Appl. No. 10/827,057
Amendment dated January 26, 2006
Reply to Office Action of October 27, 2005

AMENDMENTS TO THE DRAWINGS

DRAWINGS

FIG. 1

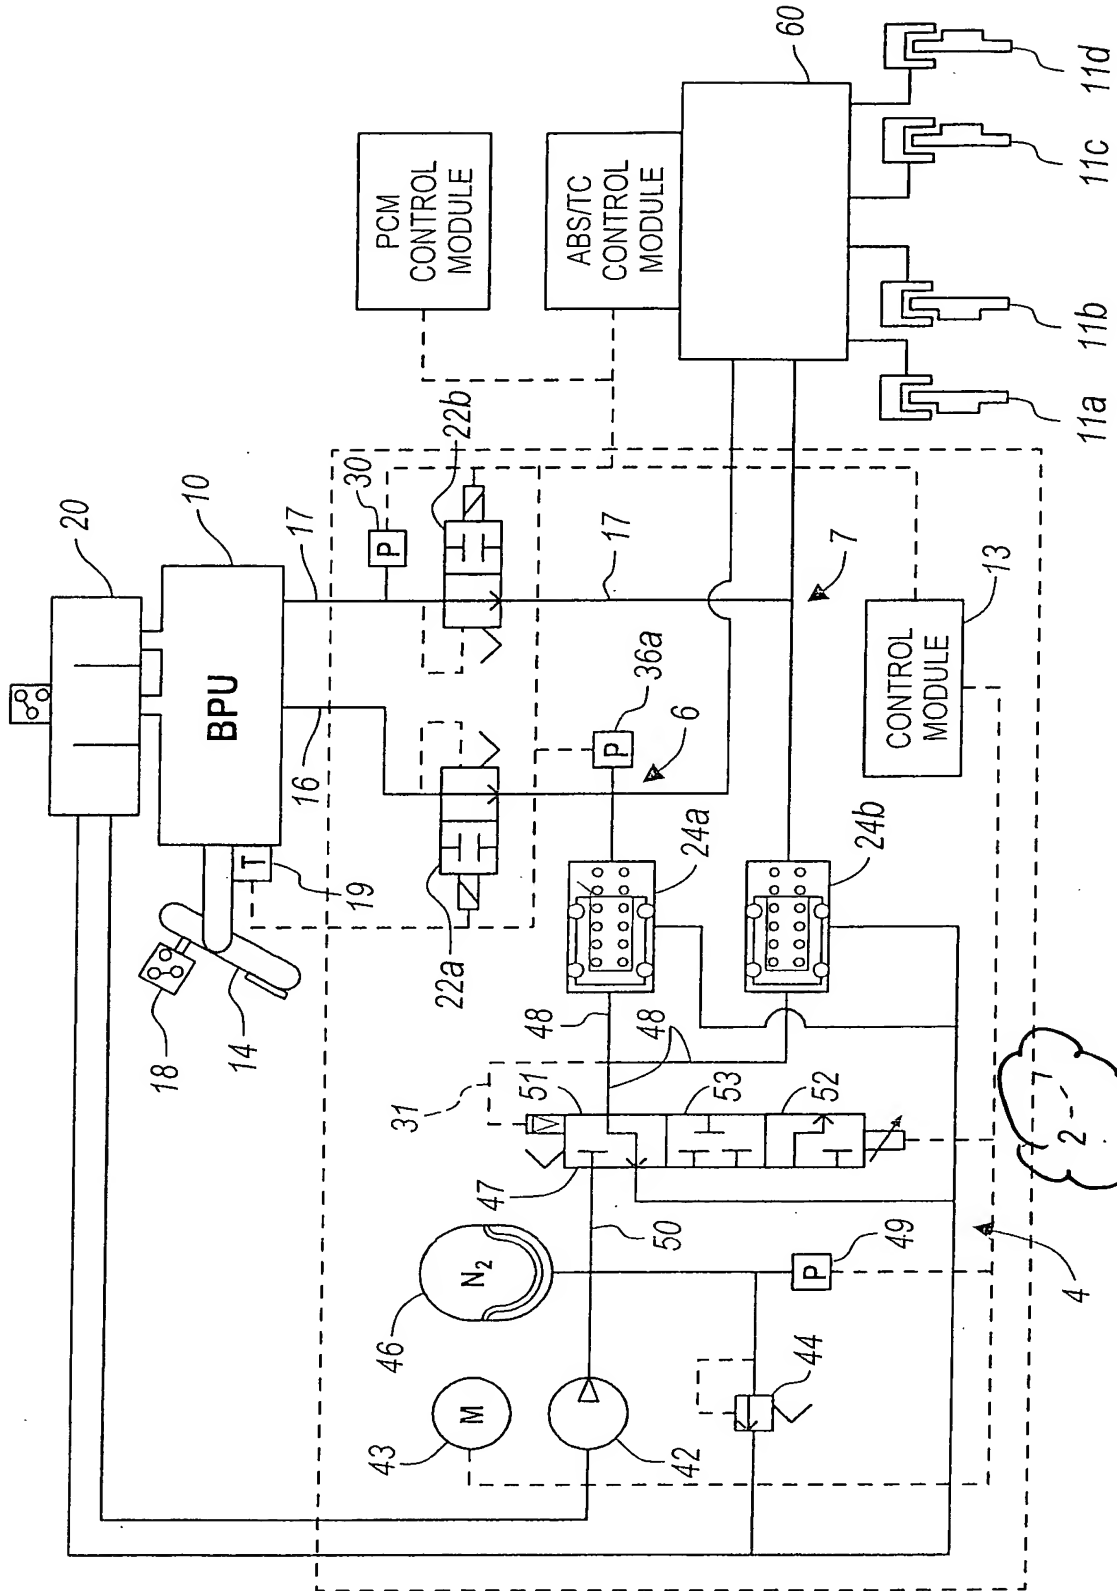
The attached sheets of drawings include amendments to Figs. 1 through 4, and 6 through 9; in each case the amendment is to add the previously omitted reference number 2. The accompanying replacement drawings replace all of the original sheets of drawings.

Replacement drawings are enclosed as an attachment. The drawings contain amendments to add reference number 2 to Figs. 1-4, and 6-9. Reference number 2 is referred to in the text, for example on page 4, line 11, to refer to a "vehicle brake module".

added

FIG. 4

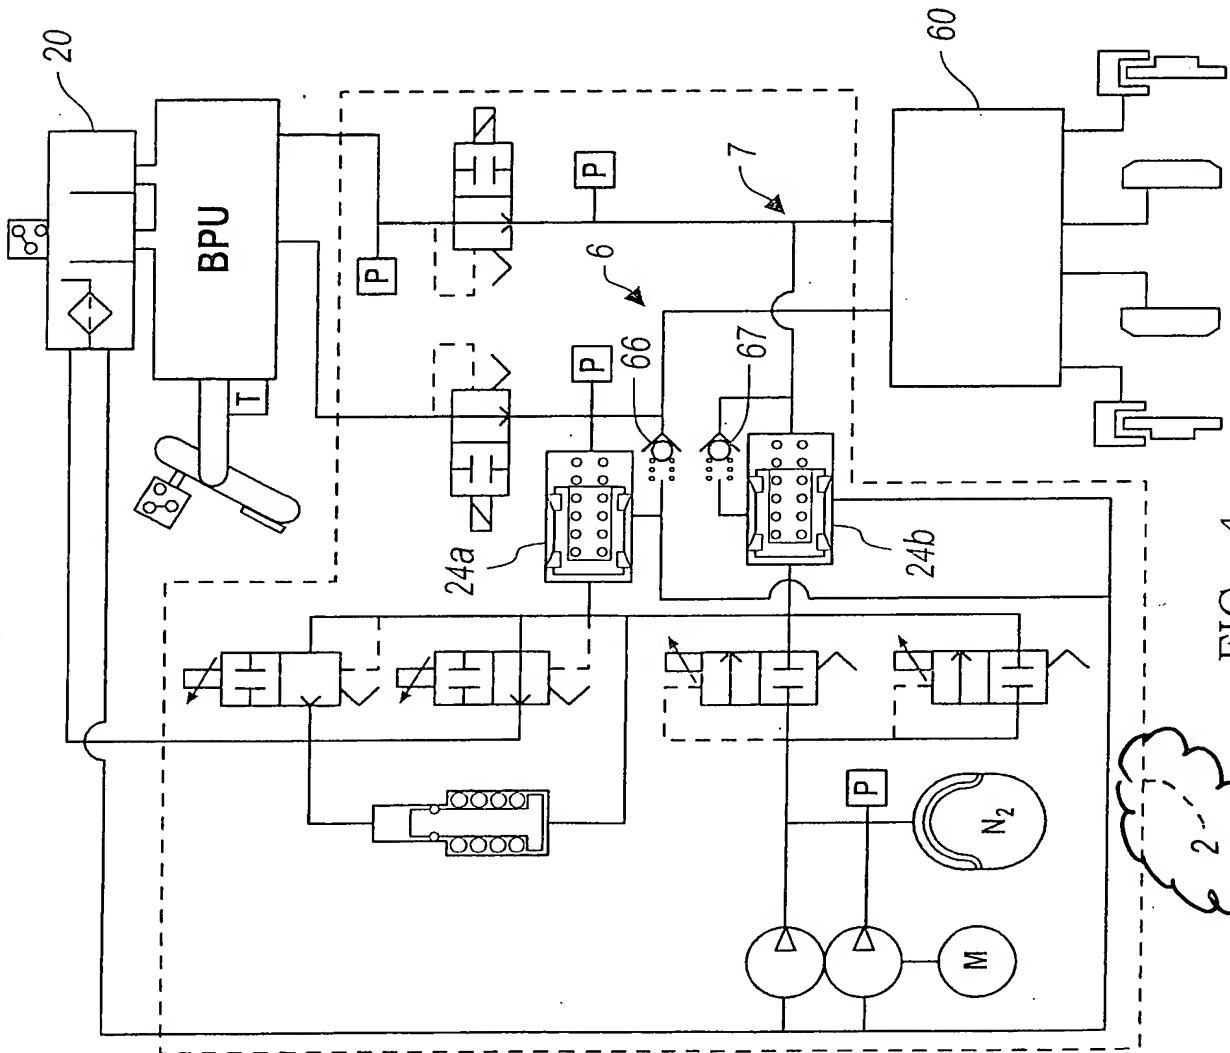
2
 added
